Project Name: Culver's
 Description: Preliminary site plan approval
 Date on Agenda this packet pertains to: May 2, 2024

RE: Culver's- Preliminary Site Plan Review – 2nd Review

RE: Culver's
Preliminary Site Plan – Review #2

JOB NO.: 230601
PHASE: P-SPA
C000

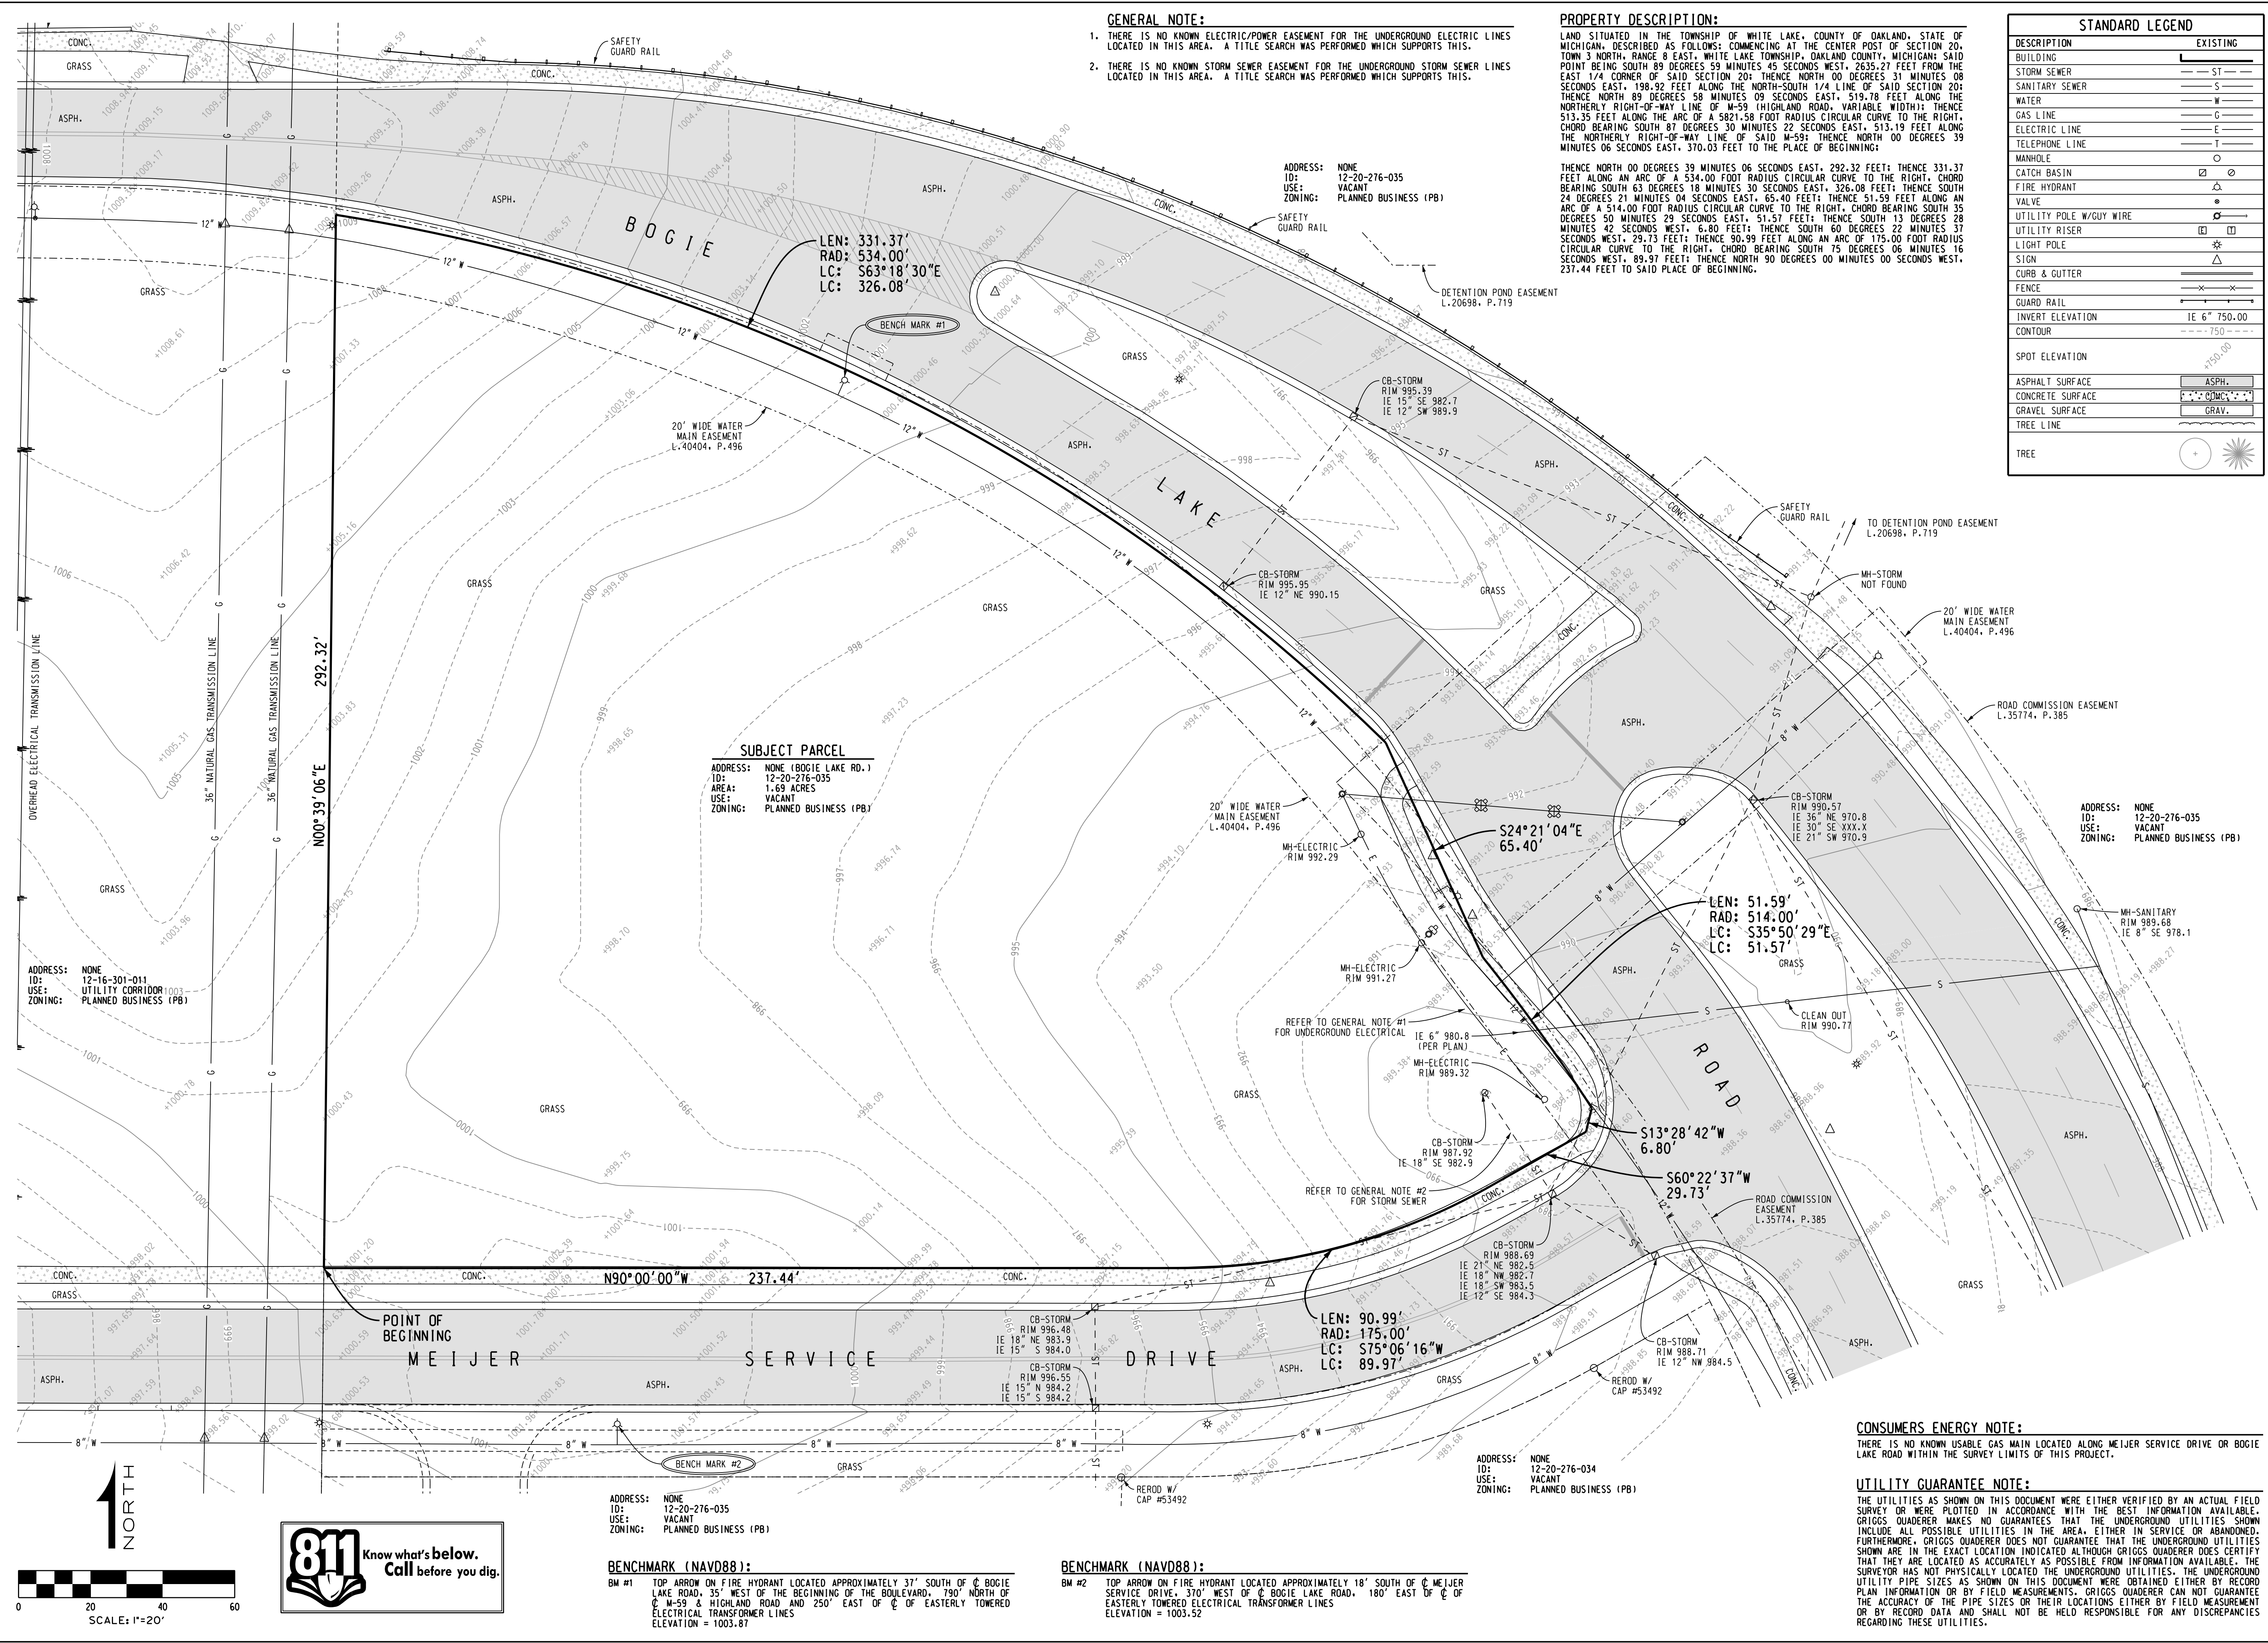
- a) *Cover sheet C000- Correct spelling of Bogie Lake Road. Currently spelled "Boagie."* **Comment addressed. Spelling has been corrected.**

PHASE: P. SPA
 JOB NO.: 230601
 10th Anniversary 2004-2023
C200

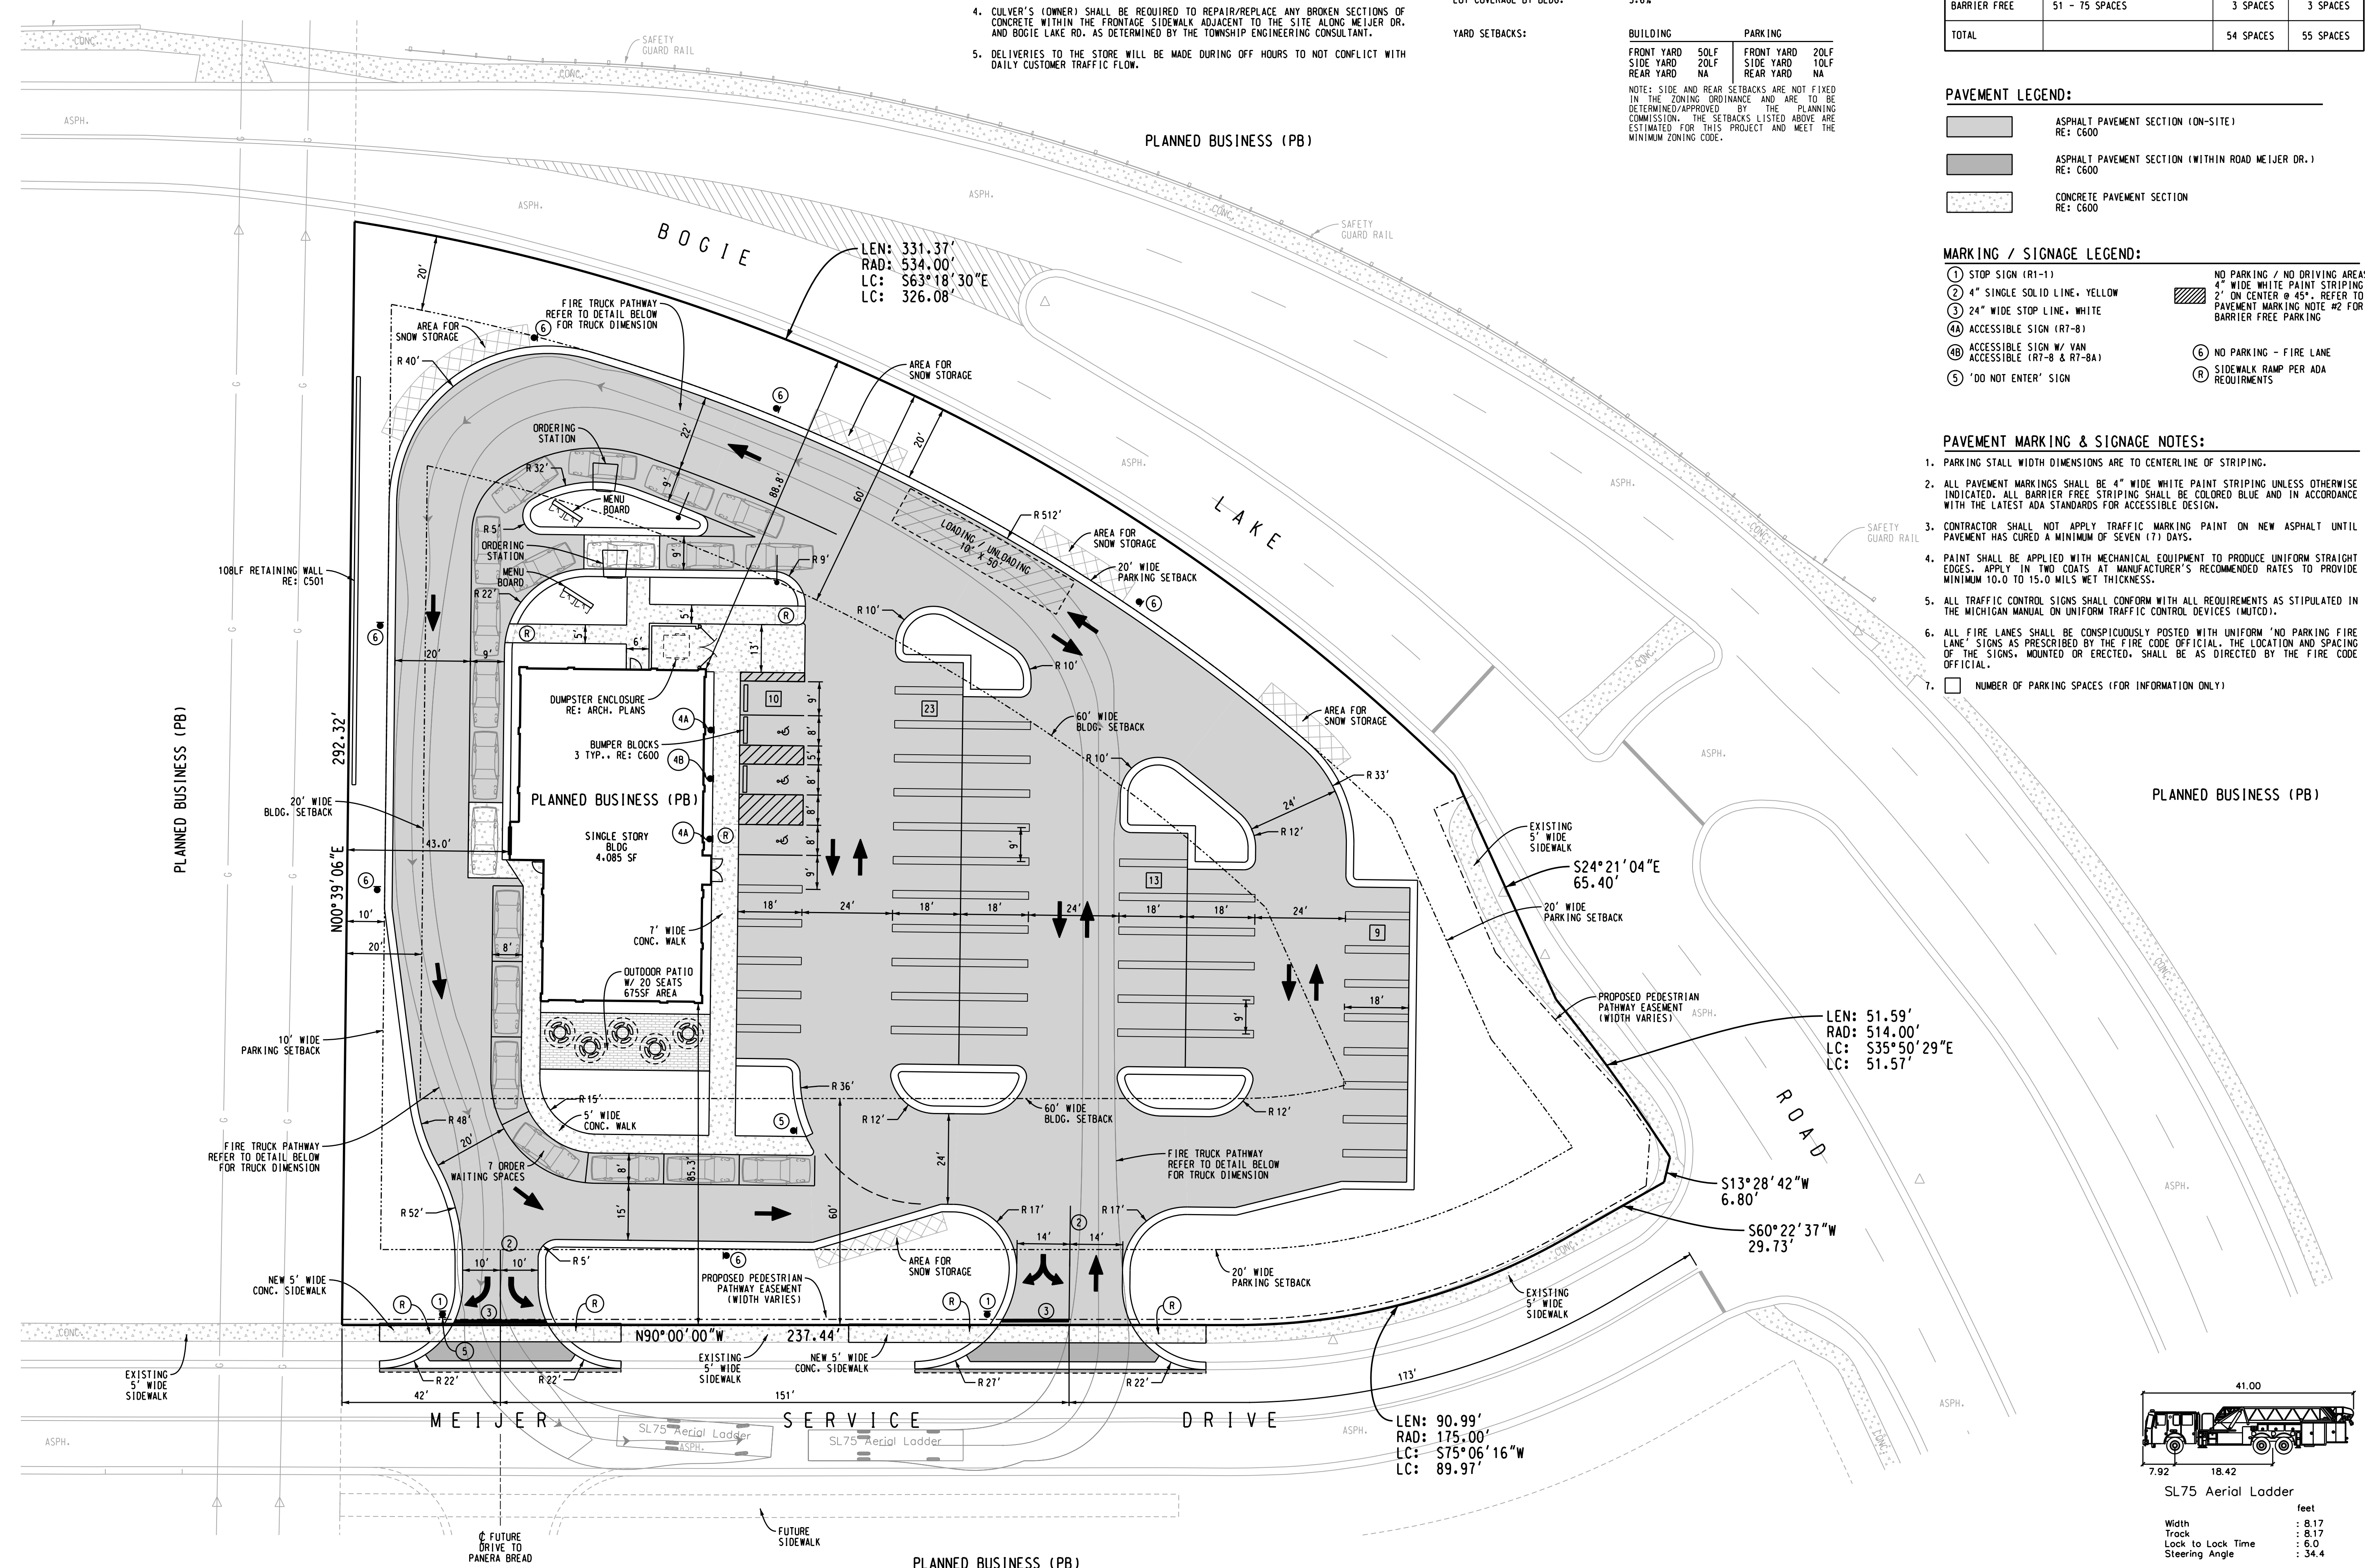
- j) *Sheet C200- It is not clear why bumper blocks are being proposed where the ADA parking + one regular parking space abut the proposed sidewalk. Although the sidewalk abutting the spaces with bumper blocks will not be raised, the sidewalk to the south at a point would still need a sloped sidewalk/ramp up to allow ADA customers access to the restaurant door since the southern portion of this sidewalk does indicate a 6" raised sidewalk. Please review. **Comment addressed and remains as a notation. The design engineer notes the sidewalk adjacent to the bumper blocks shall be flush with the pavement area, with a ramp up to the main entrance proposed. Details for ramp up to main entrance along with proposed grades (meeting ADA requirements) shall be provided on the FSP/FEP.***

- k) *Sheet C200-The 15' wide one way driveway on the south side of the restaurant does not meet the Township minimum 20' width requirement for one way drives. We defer to the Township Planning*
-

- l) *Sheet C200- Clarify the sidewalk easement intent for the existing sidewalks along the Meijer Service Drive and Bogie Lake Road. Is the easement proposed or existing? In addition, we defer to the Township Planning Department as to whether the existing sidewalk along Bogie Lake Road shall be required to be extended to the northwest along the Bogie Lake Road frontage per Township Zoning Ordinance requirements. Comment addressed and remains as a notation. A portion of the existing sidewalk is within the Culver's property and the design engineer has stated the intent to grant pedestrian access along the existing sidewalk to allow for continued use. We continue to note the requirement for a sidewalk easement for the portion of sidewalk on the Culver's property that is outside the Bogie Lake Road ROW. We continue to defer to the Township as to whether the existing sidewalk along Bogie Lake Road shall be required to be extended to the northwest along the Bogie Lake Road frontage.*

An outdoor patio with 20 seats (five tables) is proposed on the south side of the building. **Label the size (square footage) of the patio on Sheet C200. (Comment addressed. A note has been added to Sheet C200 indicating the patio is 675 square feet in size).**

Department regarding this item. Comment addressed and remains as a notation. Per the design engineer, Culver's shall be requesting a variance for the reduced drive width. We continue to defer to the Township regarding this item.
